JACKSON STREET SIDEWALK IMPROVEMENTS – PERRYMAN TO MILLER

Addendum No. 01

ADDENDUM 01

FULL DEPTH STAMPED PAVEMENT

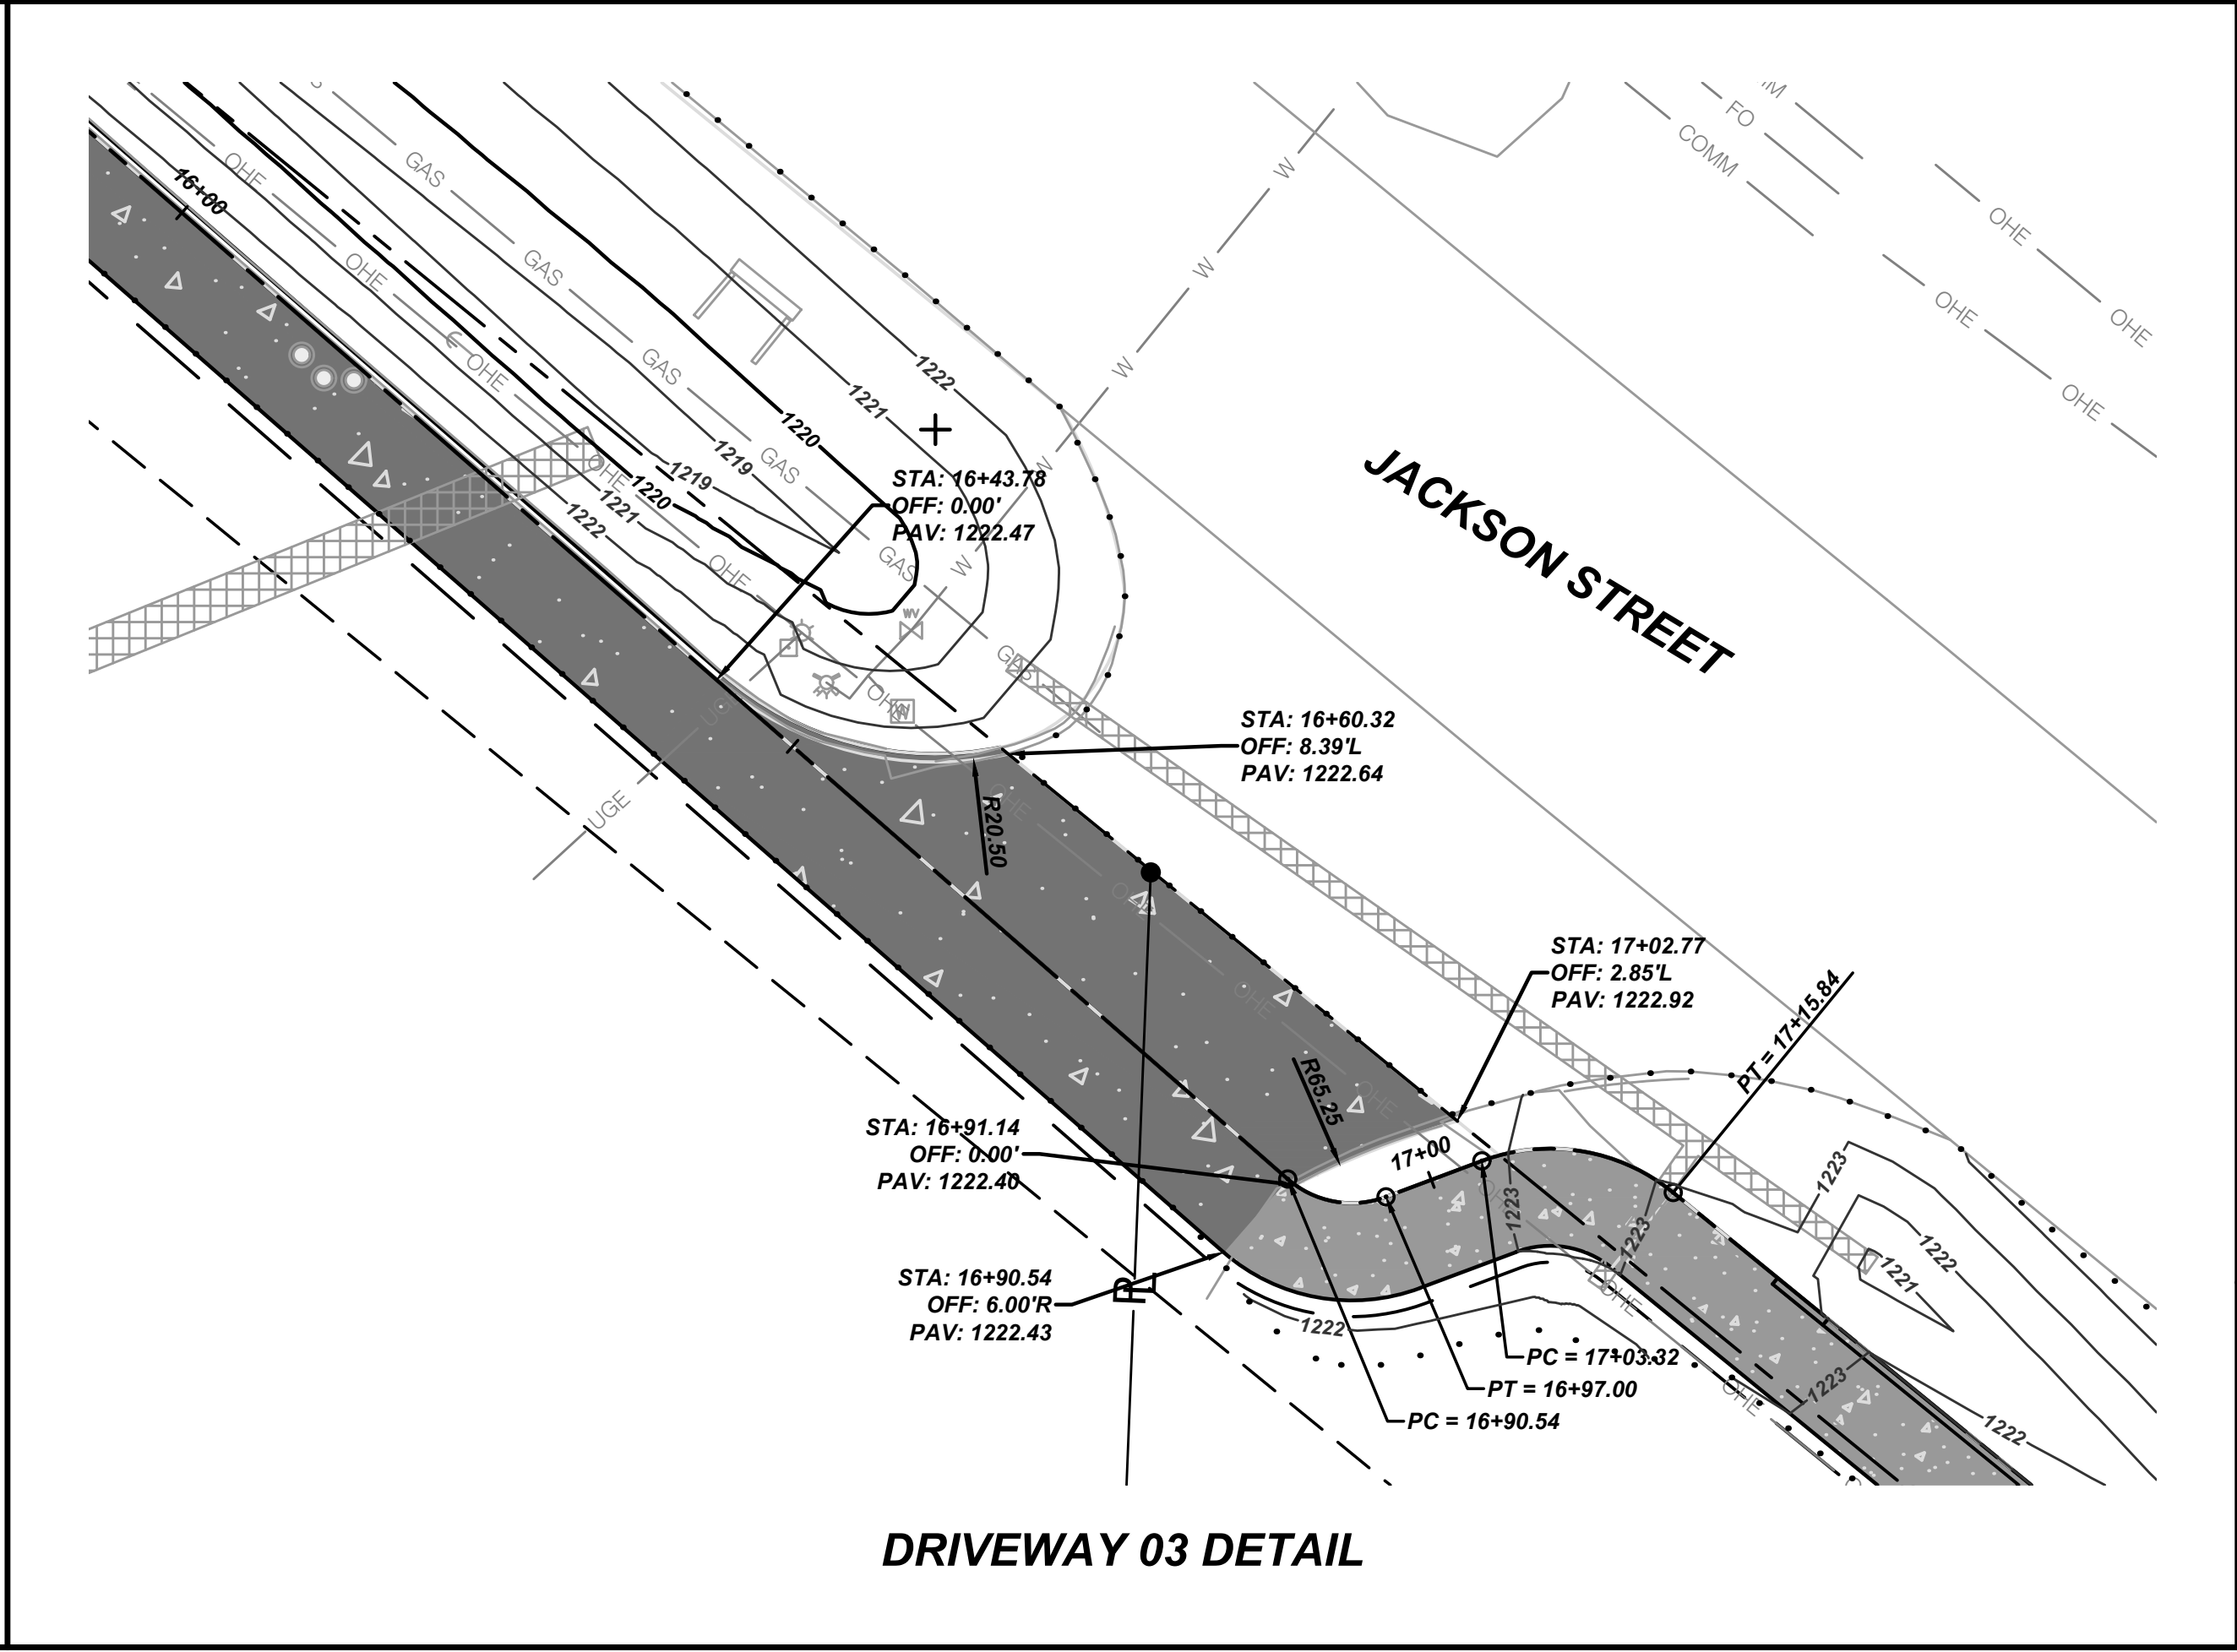
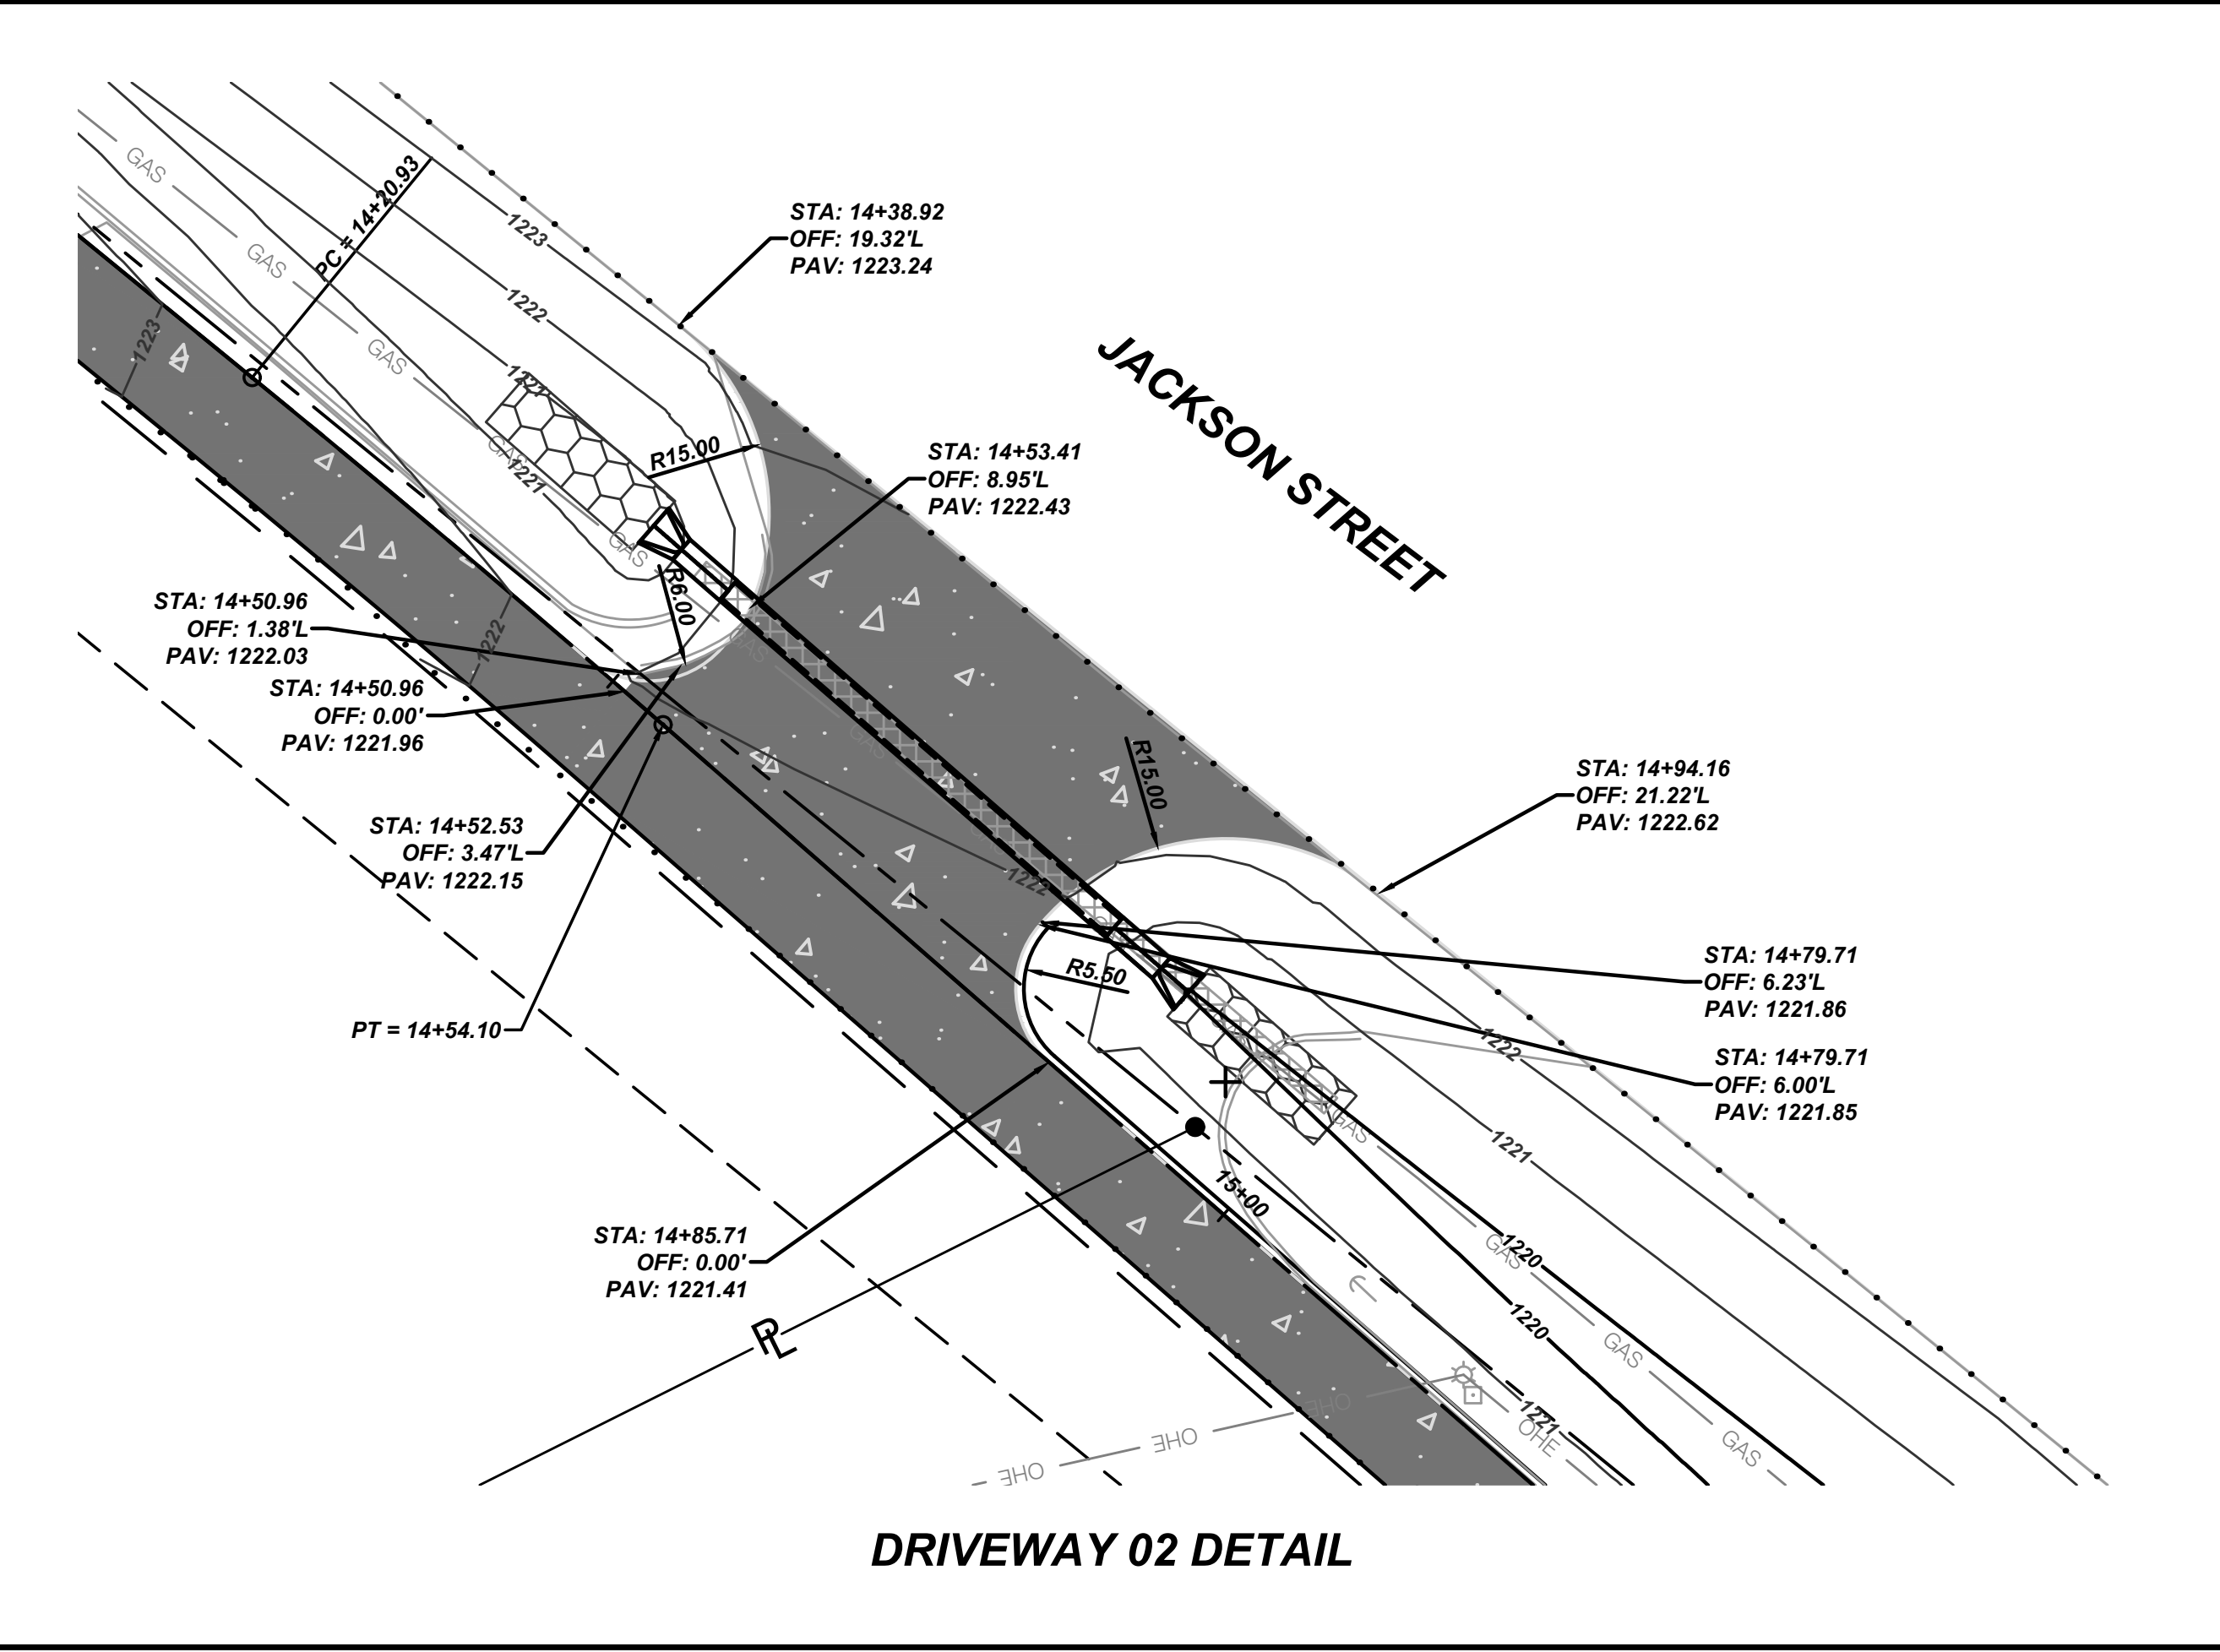
SHEET 09: The Plans have been revised to show the revised grading of Driveway 01.

EROSION CONTROL PLAN

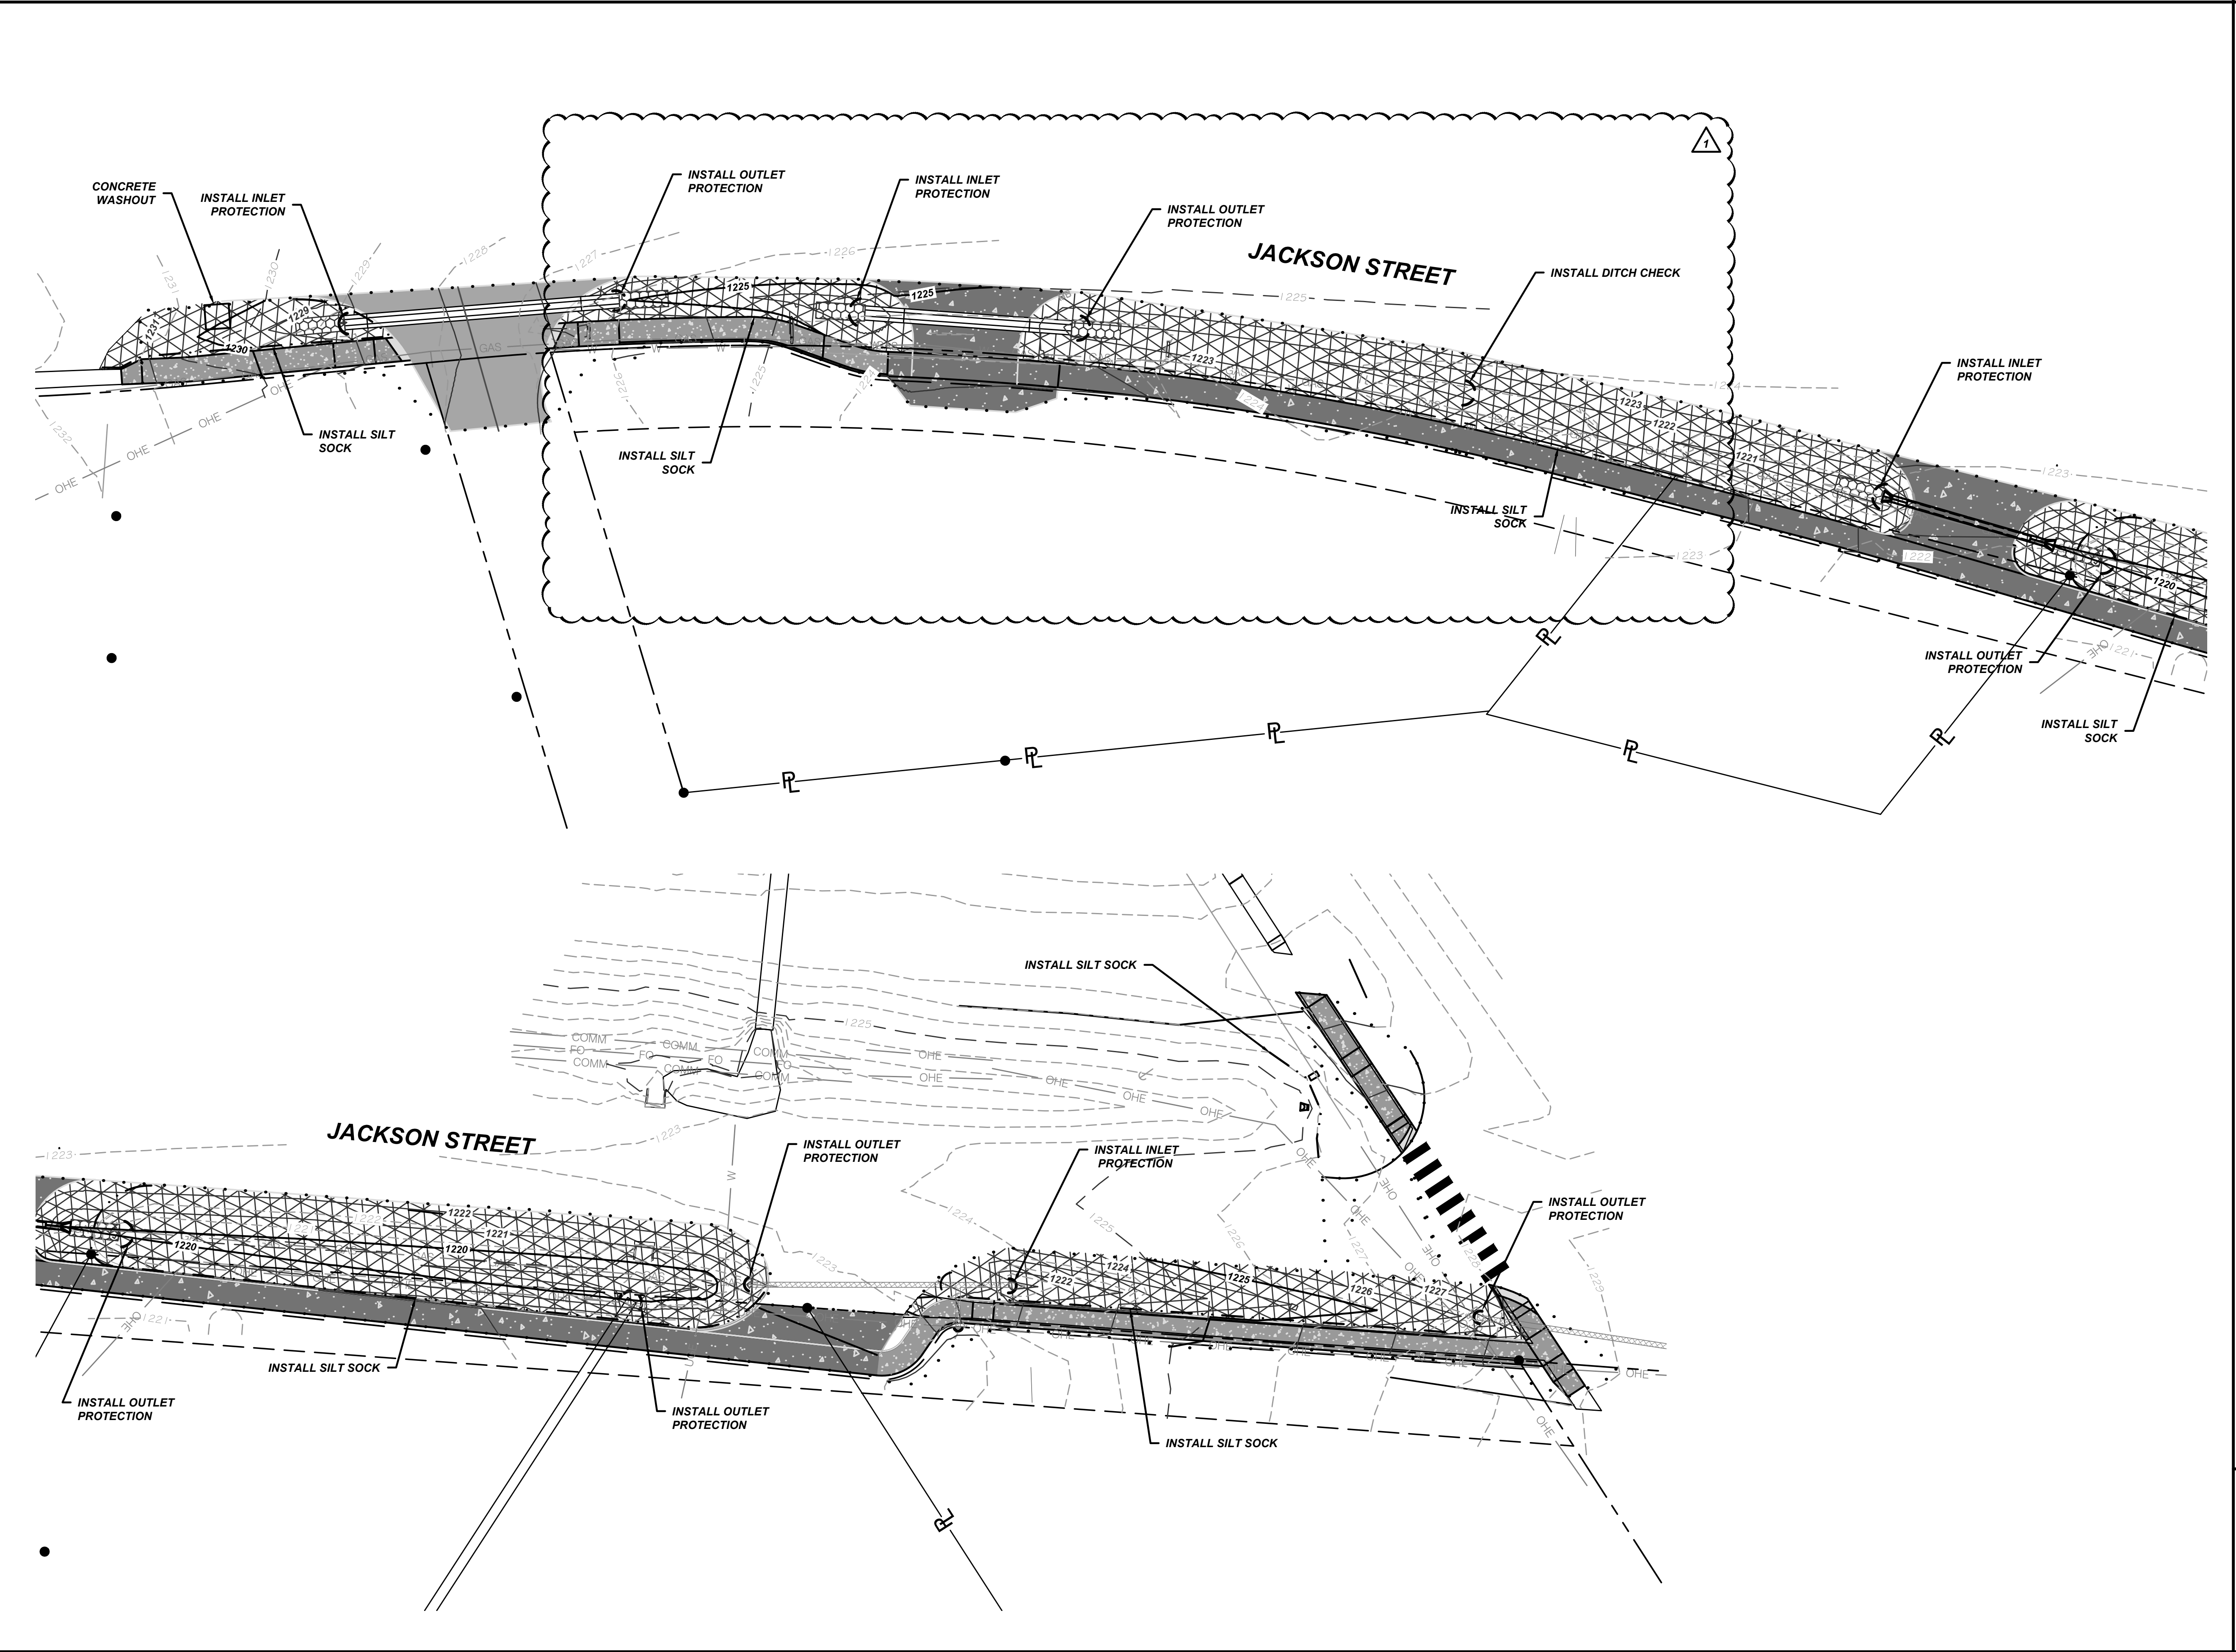
SHEET 10: The Erosion Control Measures were updated based on the new location of Driveway 01.
